SUBJECT: BYRON STATION, UNIT NOS. 1 AND 2 - REQUESTS FOR RELIEF FROM THE ASME CODE REQUIREMENTS FOR THE THIRD 10-YEAR INTERVAL INSERVICE INSPECTION PROGRAM PLAN (TAC NOS. MD3661, MD3662, AND MD3663)

SAFETY EVALUATION BY THE OFFICE OF NUCLEAR REACTOR REGULATION

RELATED TO RELIEF REQUEST NOS. I3R-09 AND I3R-10

THIRD 10-YEAR INTERVAL INSERVICE INSPECTION PROGRAM PLAN

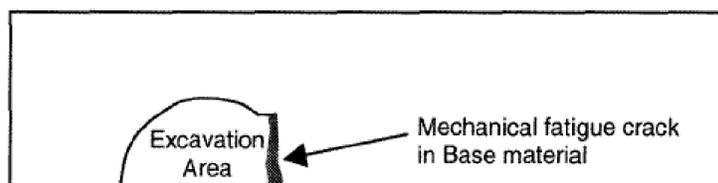
Technical Basis - As illustrated below, implanting a crack requires excavation of the base material on at least one side of the flaw. While this may be satisfactory for ferritic materials, it does not produce a useable axial flaw in austenitic materials because the sound beam, which normally passes only through base material, must now travel through weld material on at least one side, producing an unrealistic flaw response. In addition, it is important to preserve the dendritic structure present in field welds that would otherwise be destroyed by the implantation process. To resolve these issues, the proposed alternative allows the use of up to 40% fabricated flaws as an alternative flaw mechanism under controlled conditions. The fabricated flaws are isostatically compressed which produces ultrasonic reflective characteristics similar to tight cracks.

The ASME Code requires all flaws to be cracks. Manufacturing test specimens containing cracks free of spurious reflections and telltale indicators is extremely difficult in austenitic material. To overcome these difficulties, PDI developed a process for fabricating flaws that produce UT acoustic responses similar to the responses associated with real cracks. PDI presented its process for discussion at public meetings held June 12 through 14, 2001, and January 31 through February 2, 2002, at the EPRI Nondestructive Examination Center, Charlotte, NC. The NRC staff attended these meetings and determined that the process parameters used for manufacturing fabricated flaws resulted in acceptable acoustic responses. PDI is selectively installing these fabricated flaws in specimen locations that are unsuitable for real cracks. As such, the NRC staff agrees that the acoustic responses of the fabricated flaws are sufficiently similar to those of real cracks to provide test conditions that are consistent with the purpose of the ASME Code requirements. Consequently, the NRC staff finds that the proposed alternative will provide an acceptable level of quality and safety, and therefore, is acceptable.
